IMMEDIATE STOP USE AND INSPECT NOTICE FOR PARK TOOL CRANK PULLERS

Park Tool has issued a Stop Use and Inspect Notice for their CCP-22, CCP-44 and CWP-7 crank pullers due to an out-of-spec nut that is shared between the three tools. This out-of-spec threading may cause damage to bicycle cranks during removal. Some, but not all, tools sold between October 2021 and April 2022 may be affected. PART NUMBERS AFFECTED: Park Tool CCP-22, CCP-44 and CWP-7 Crank Pullers. MANUFACTURED DATE: Some, but not all, tools purchased between October 2021 and April 2022 may be affected.

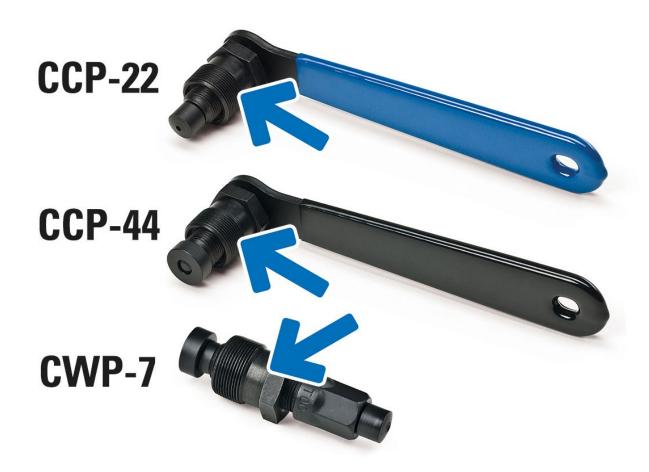
INSPECTION OF TOOL: To see if your tool is affected, locate the nut on each of the tools per the images below and inspect the threading.

Bad threads will have a flat peak, and the improper thread peaks will extend almost halfway down the threading of the nut. The non-affected tools have sharper and consistent thread peaks throughout the length of the nut, as shown in the picture.

Park Tool will replace nuts with bad threads at no cost.

If you have inspected your puller, and have determined you need a replacement nut: CUSTOMERS IN THE UNITED STATES: Visit <u>parktool.com/1206</u>, and follow the instructions.
